DATE: 06.08.2016

FROM: Bill McDow
Transportation Planning

■ **44 DARLINGTON AVE STORAGE BUILDING [TRC Plan Review]**

∞ Initial Review Note ∞

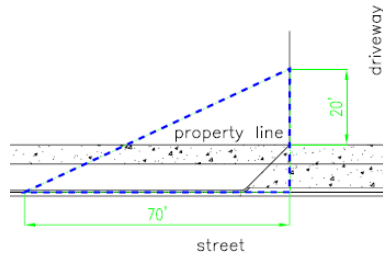
- Revise all sheets to accurately illustrate the proposed and existing driveway conditions. The demolished driveway was left on the site plan CS-201 and CS-241, which makes it difficult to see the proposed plan details.
- If pavement markings on site have weathered to the point they are not in accordance with the MUTCD standard of maintenance, do not show the markings as existing, and rather show them as proposed on the site plan.
